# Amendment Report

EnergyConnect (NSW – Eastern Section)

May 2022

Figure 3-2

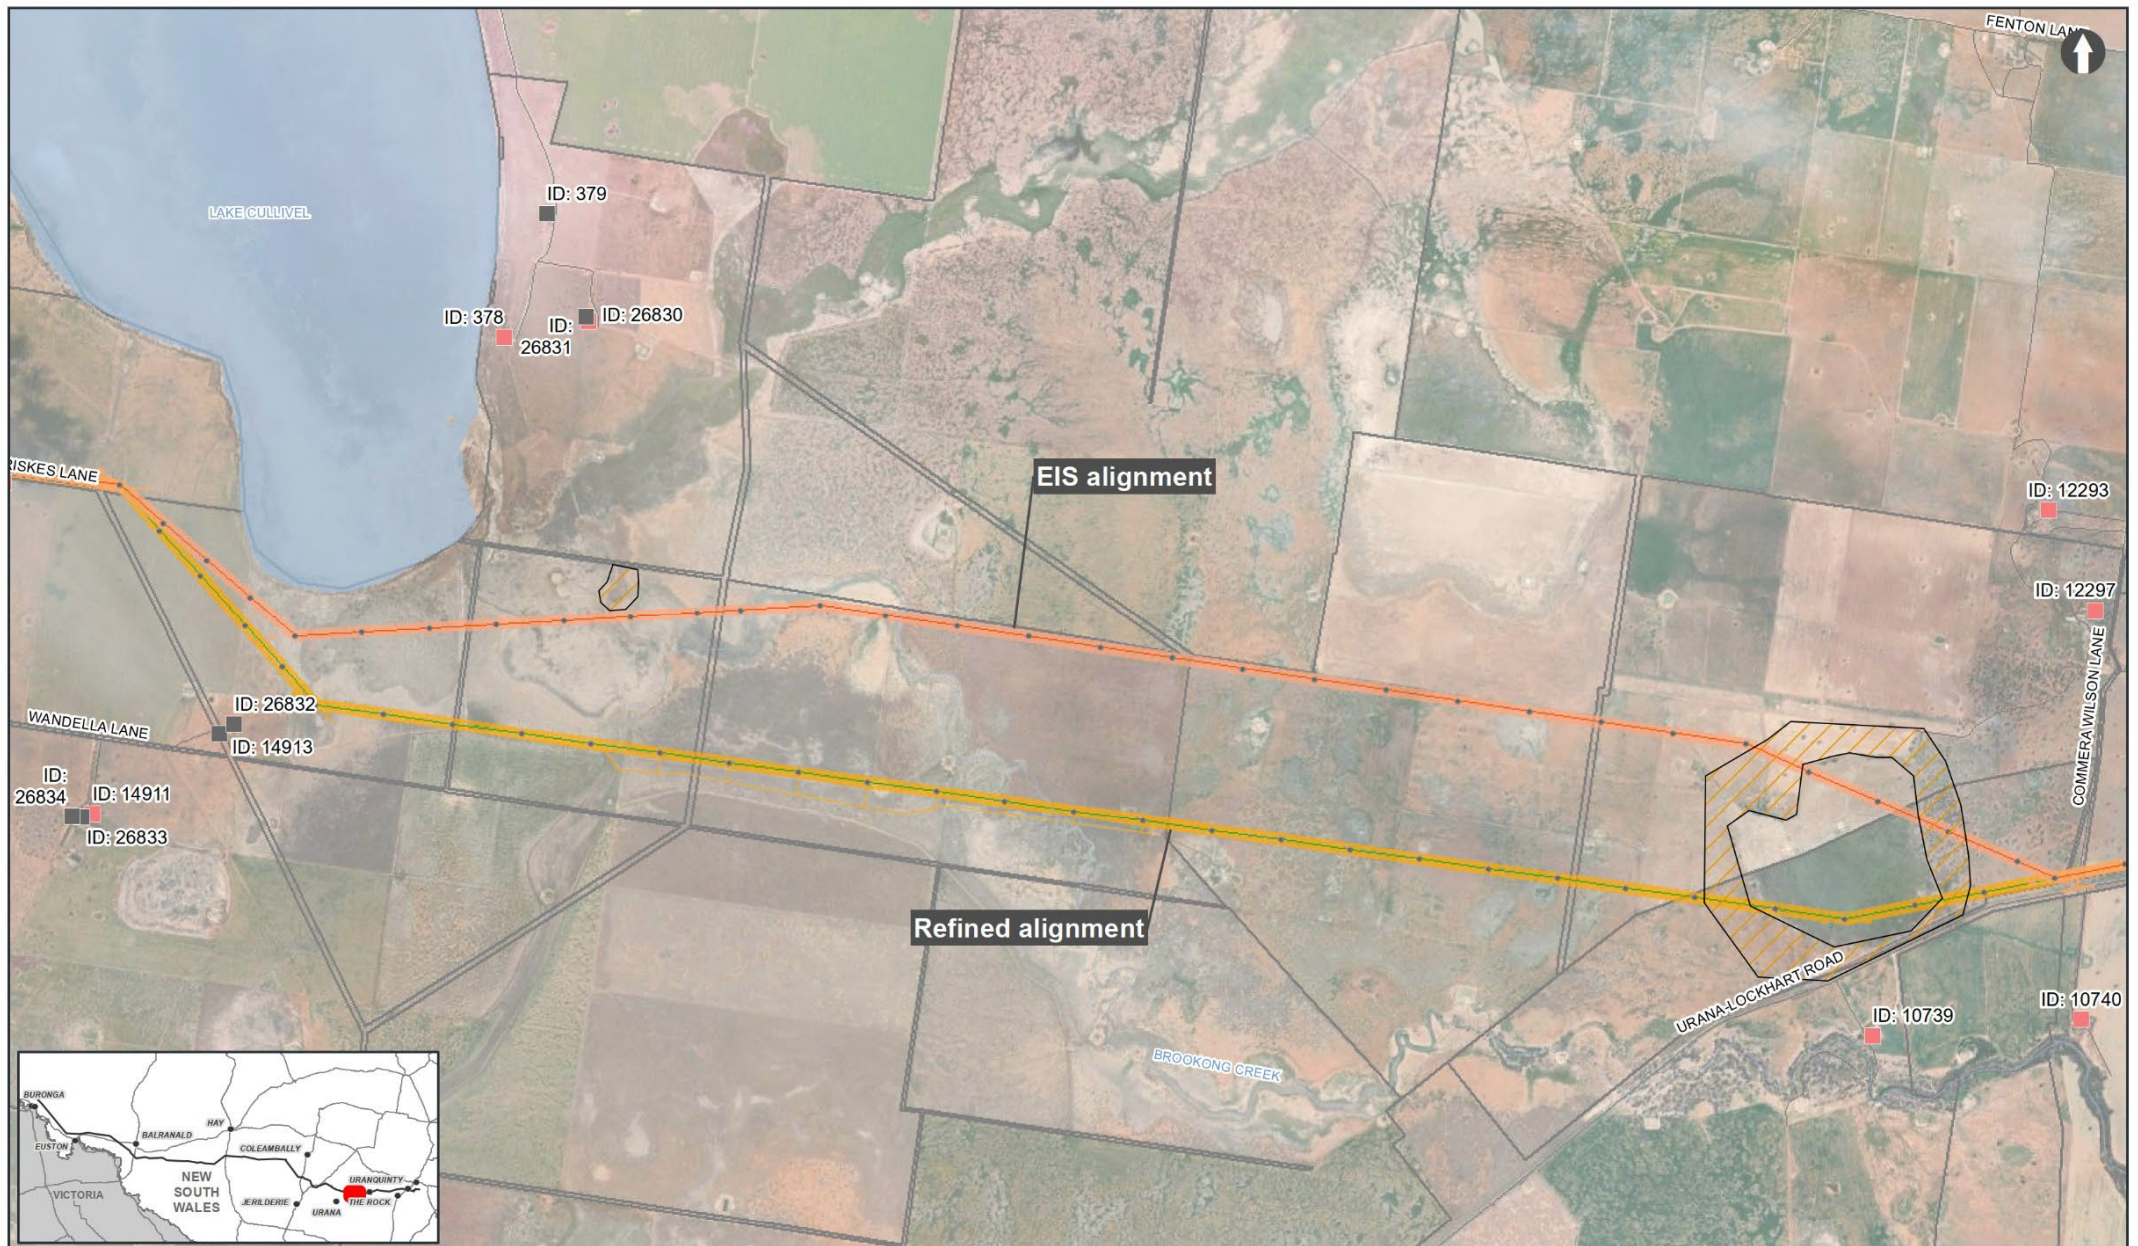
Figure 3-2 shows a comparison between the EIS alignment and the refined alignment within the vicinity of Lake Cullivel.

**Figure 3-4**

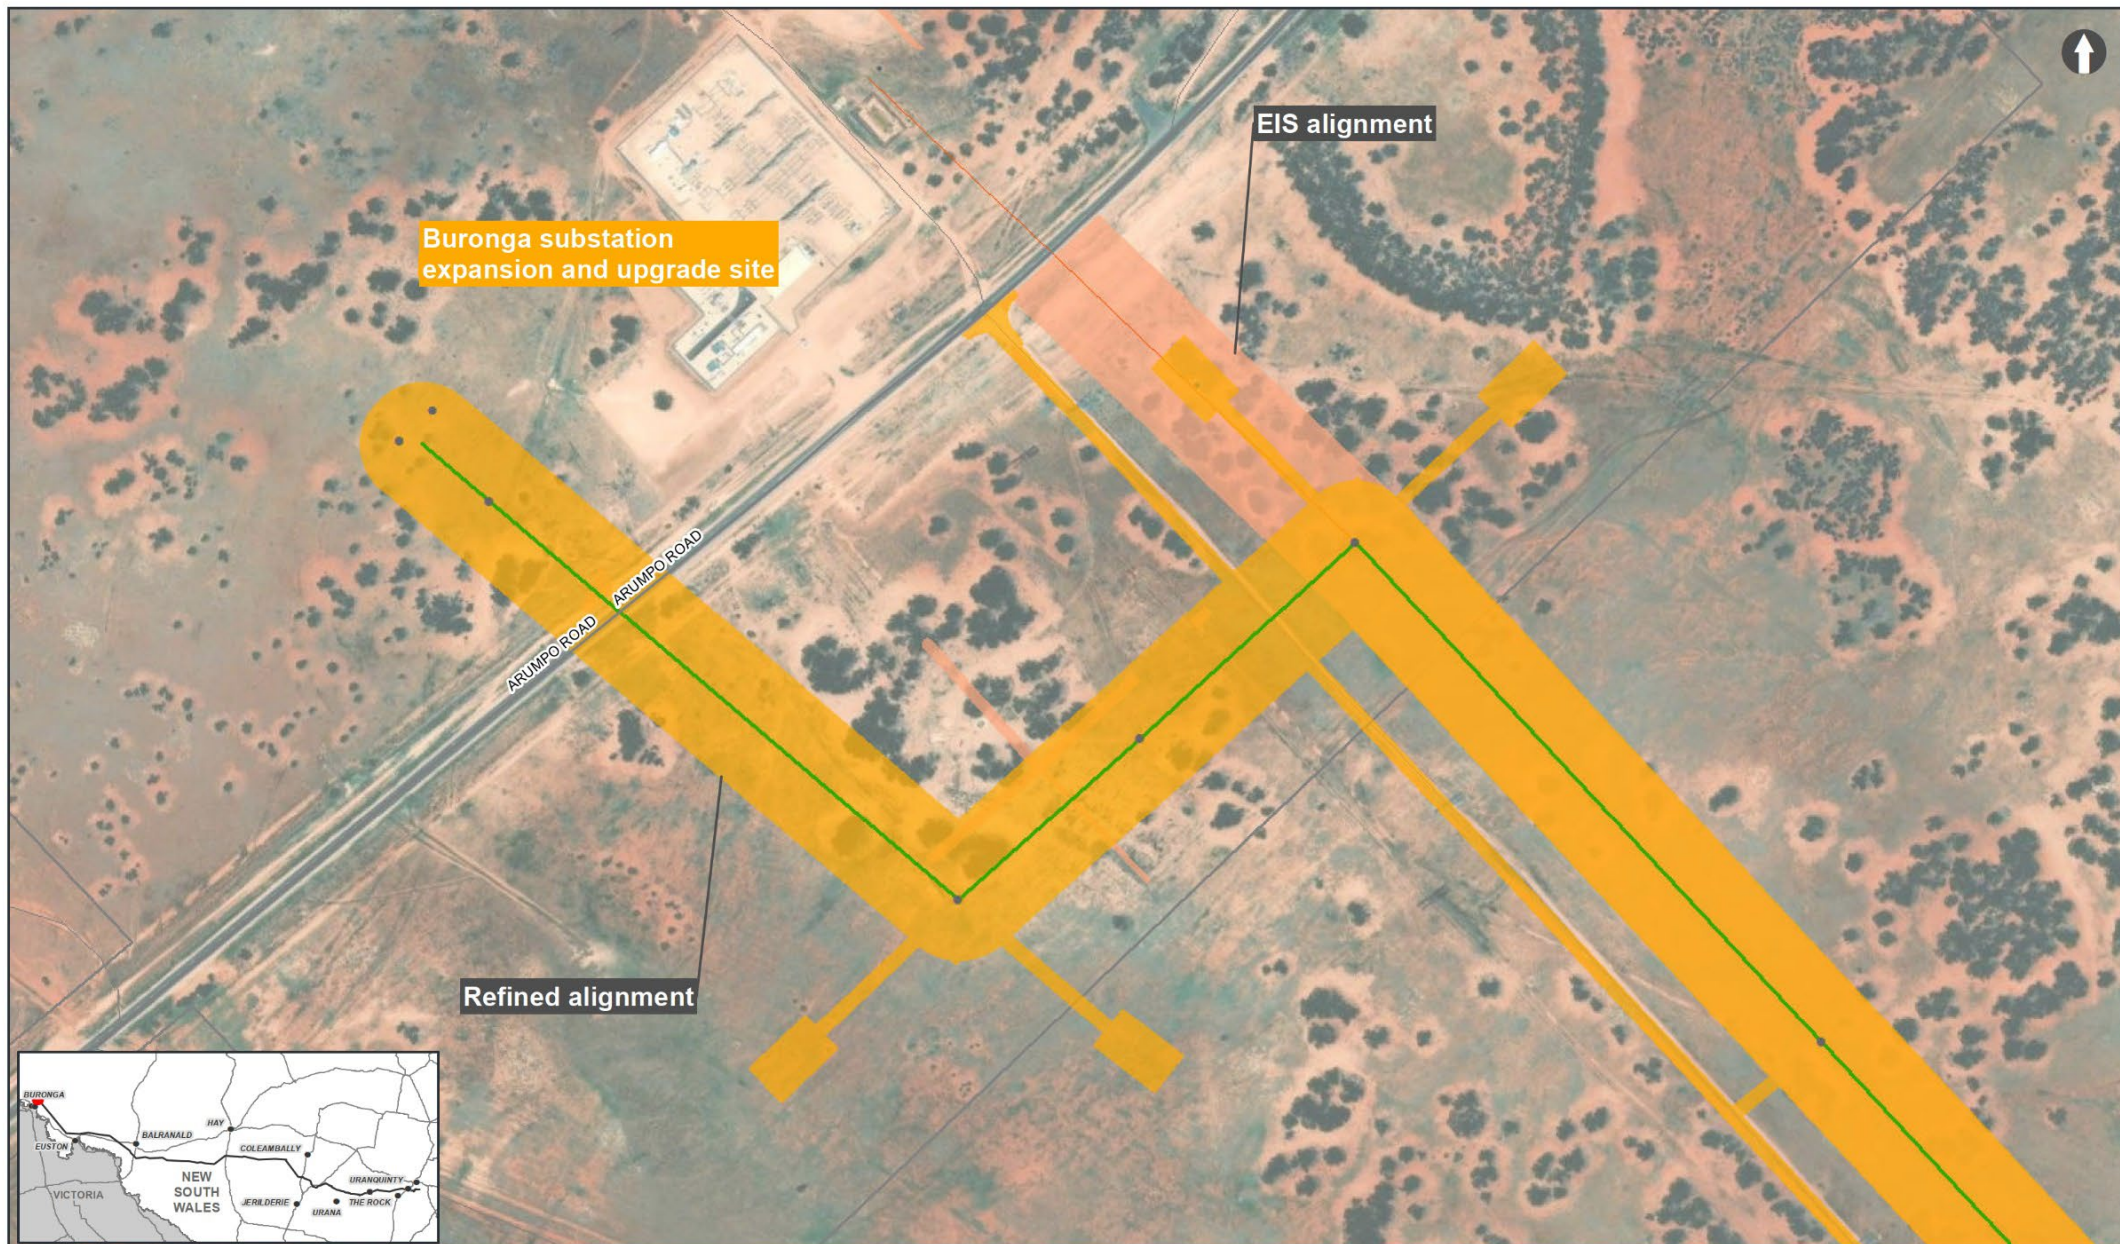
The new transmission line connection point would be located around 370 metres to the south west of the connection point identified for the EIS alignment. As a result of this shift, a new alignment for the transmission line would be required for around the first 300 metres of the proposal. The refined alignment would be around 680 metres in length (an increase of around 350 metres in comparison to the EIS alignment) and would require one additional transmission line tower (in comparison to the EIS alignment).

Figure 3-4 shows a comparison between the EIS alignment and the refined alignment at the access point to the Buronga substation.

Figure 3-5

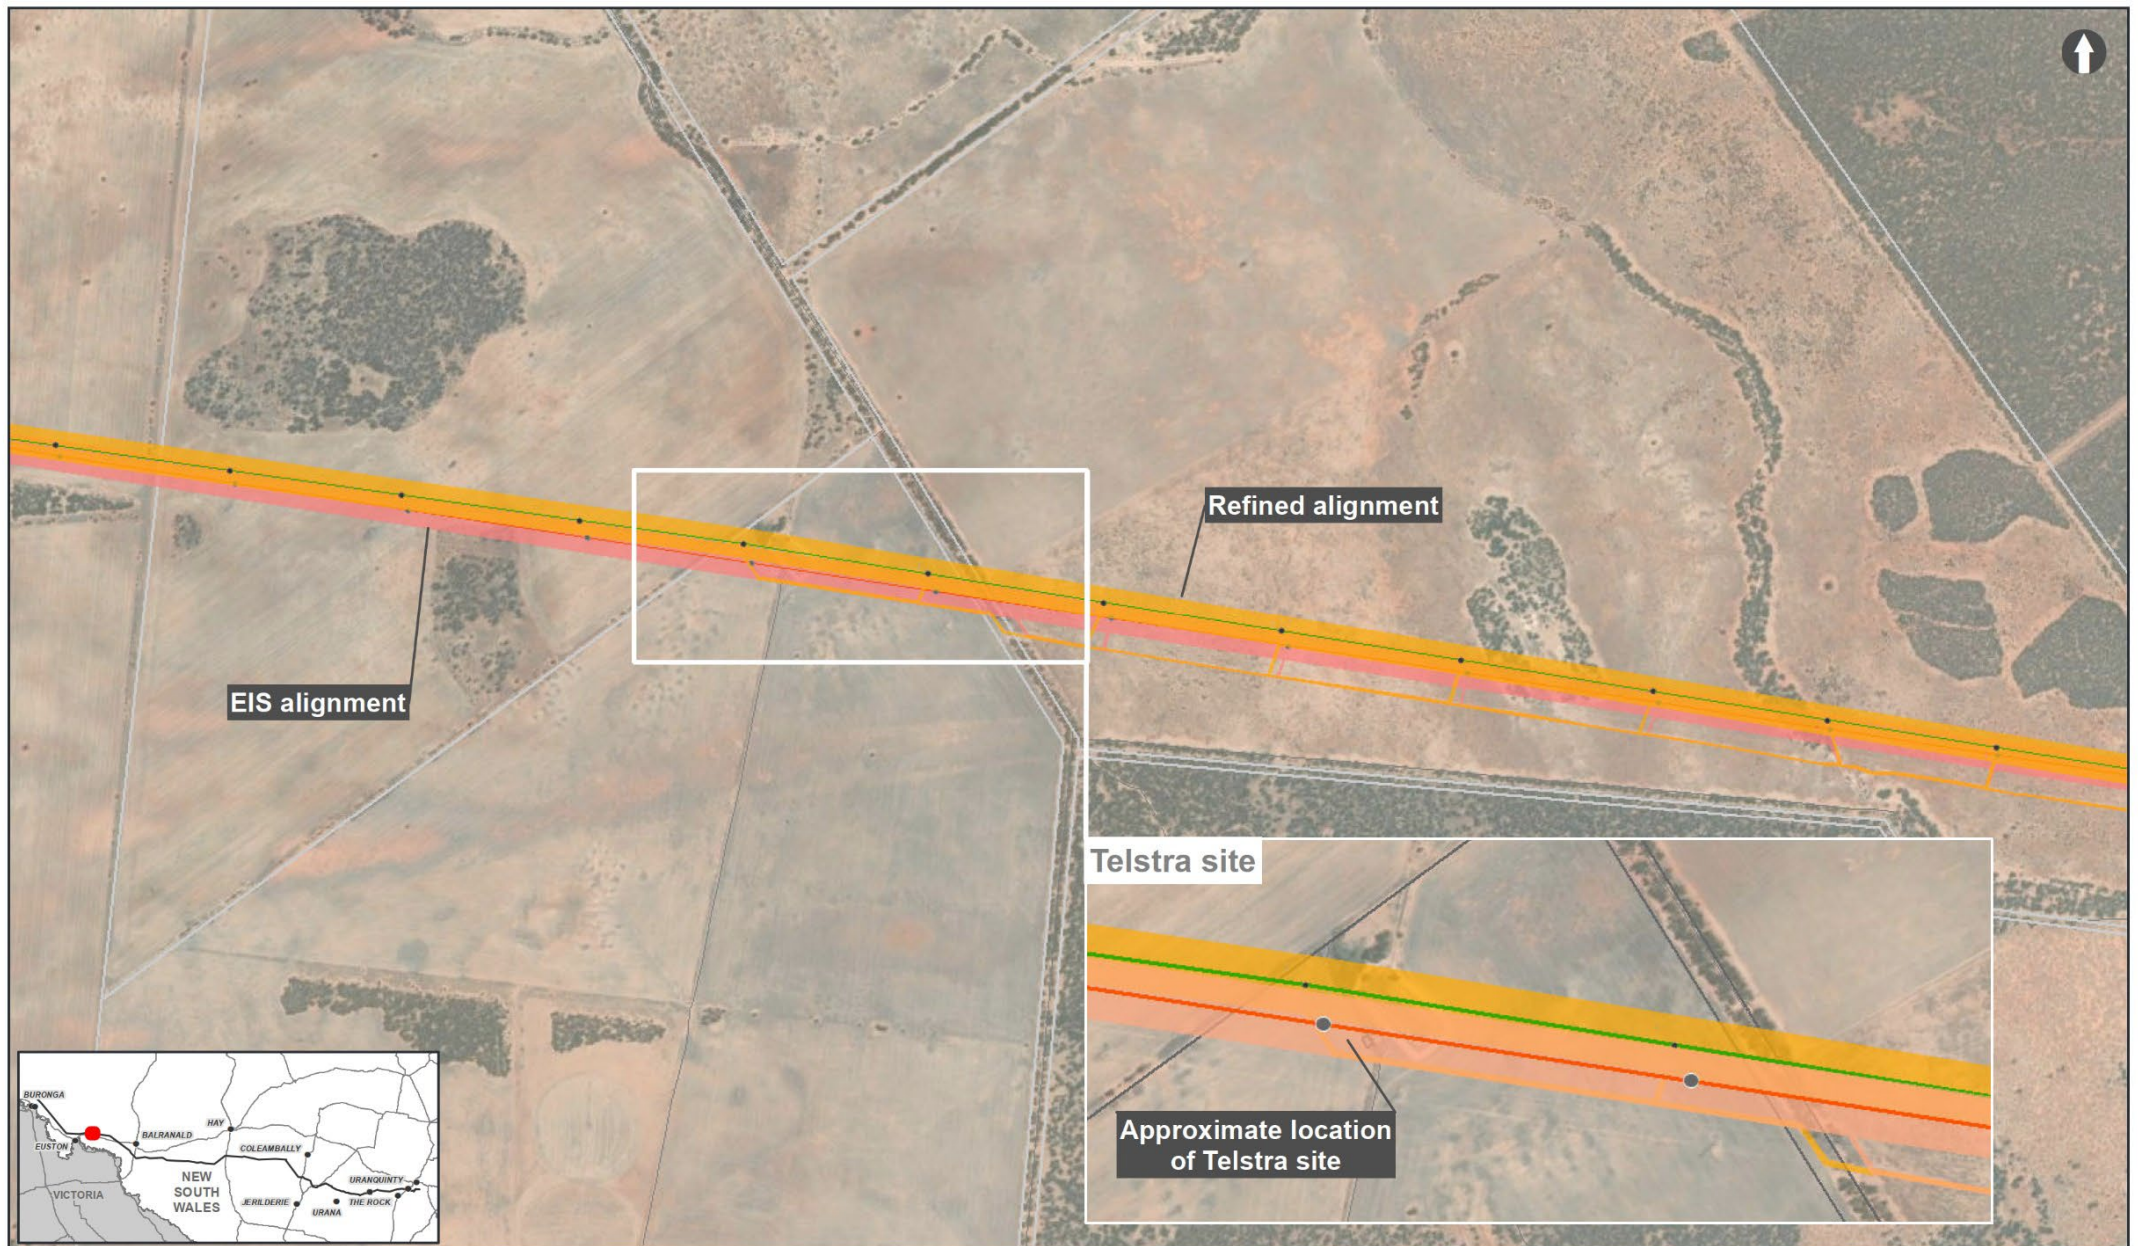
As part of ongoing consultation with key stakeholders, a Telstra infrastructure site was identified as being impacted by the EIS alignment. To avoid this site, around seven kilometres of the alignment to the north of the Sturt Highway and east of Benanee has been slightly adjusted. At the greatest deviation from the EIS alignment, the refined alignment would result in a shift of the transmission line easement by around 50 metres to the north and result in the adjustment of around 15 transmission line tower footprint locations.

Figure 3-5 shows a comparison between the EIS alignment and the refined alignment at the access point to the Buronga substation.

Figure 3-6

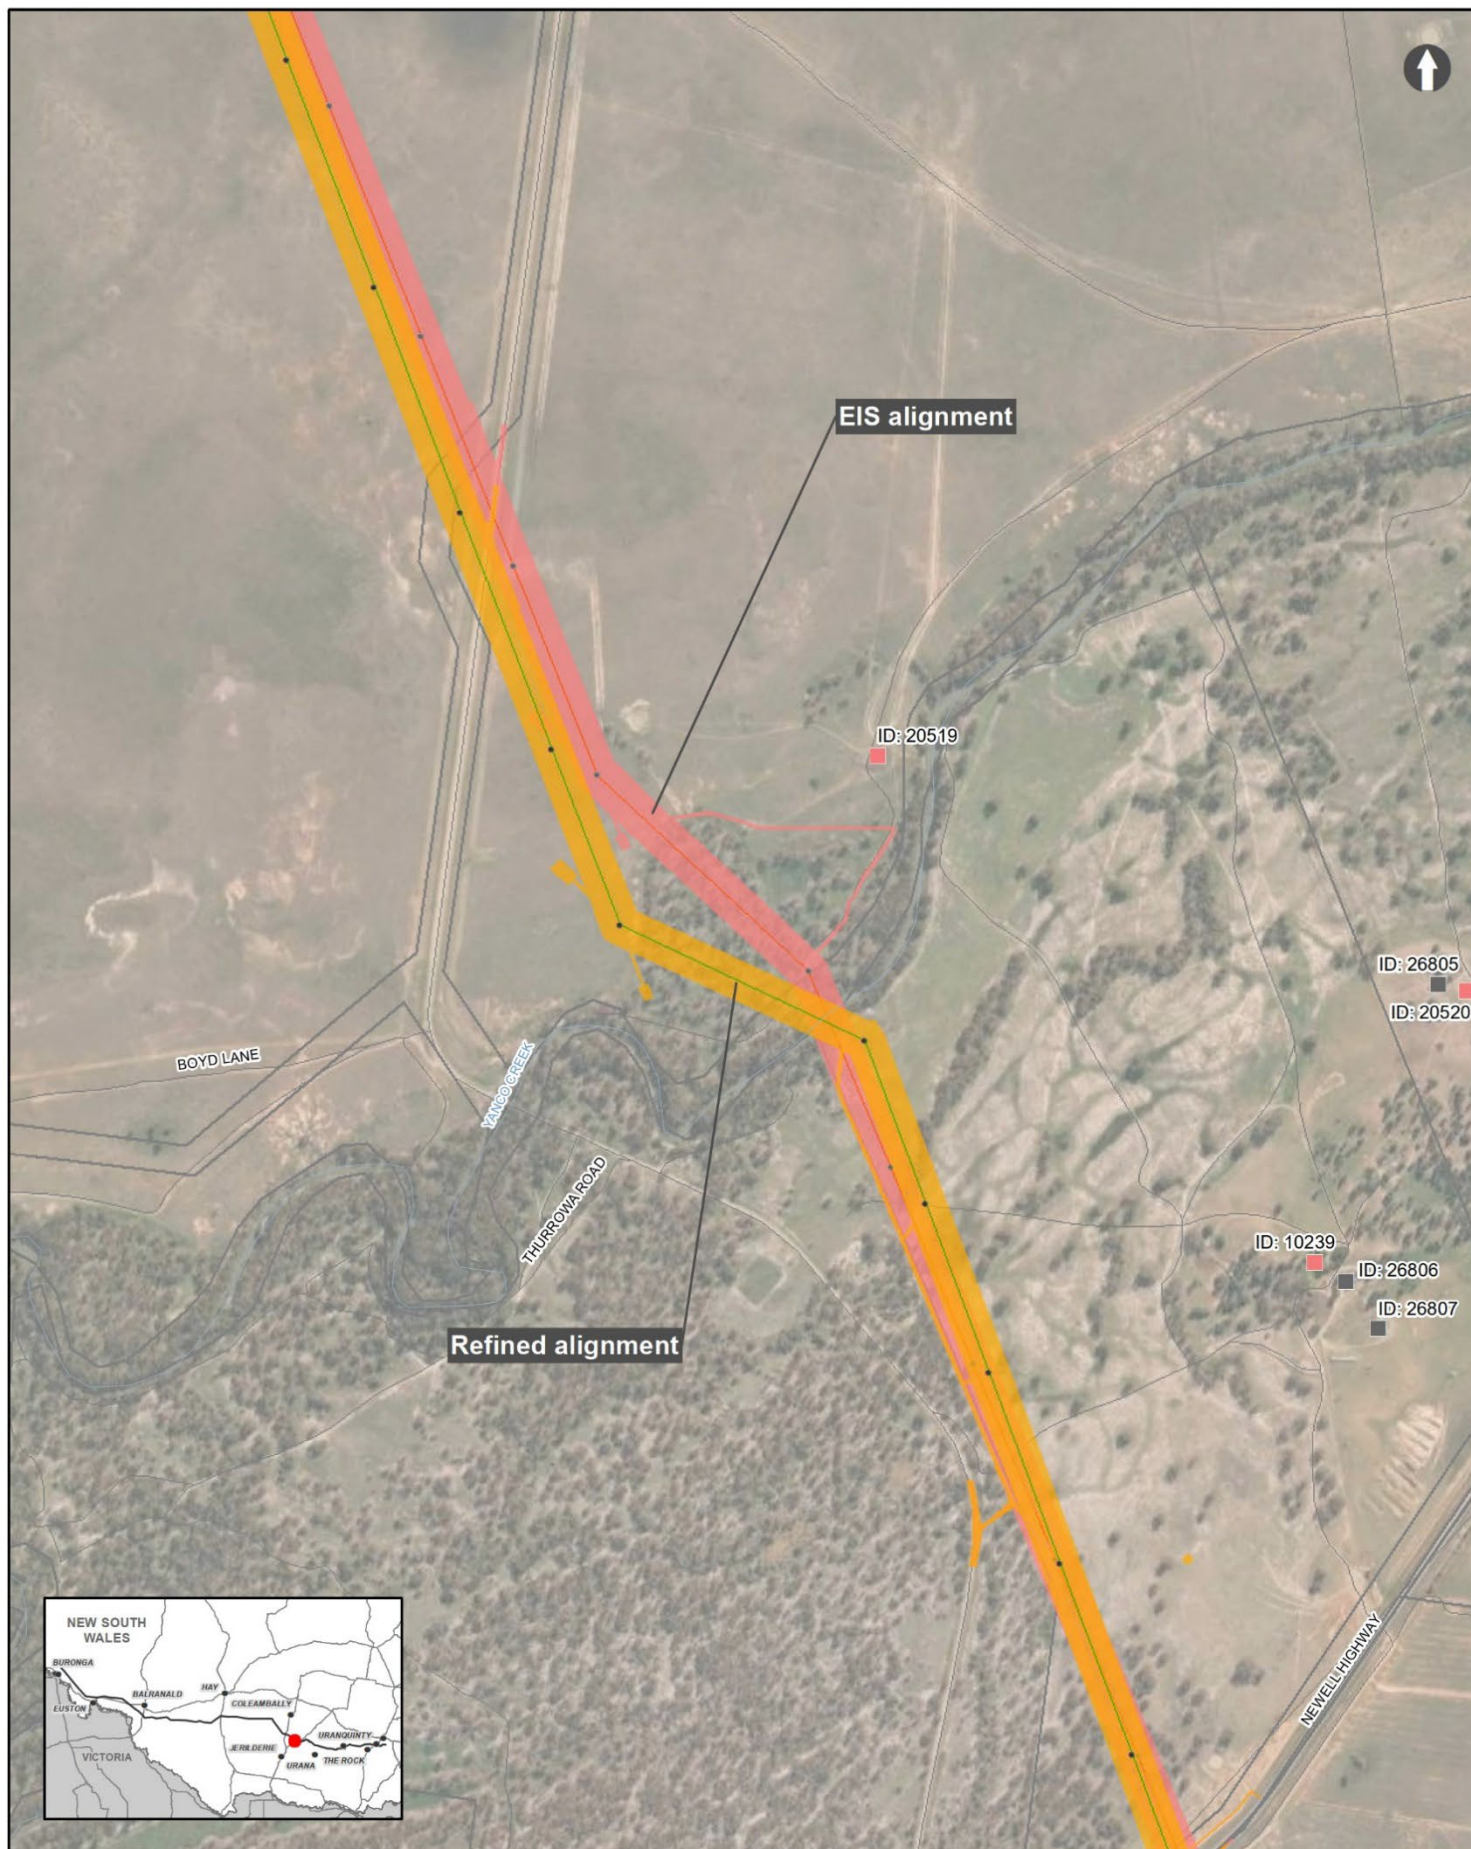
Figure 3-6 shows a comparison between the EIS alignment and the refined alignment within the vicinity of Yanco Creek.
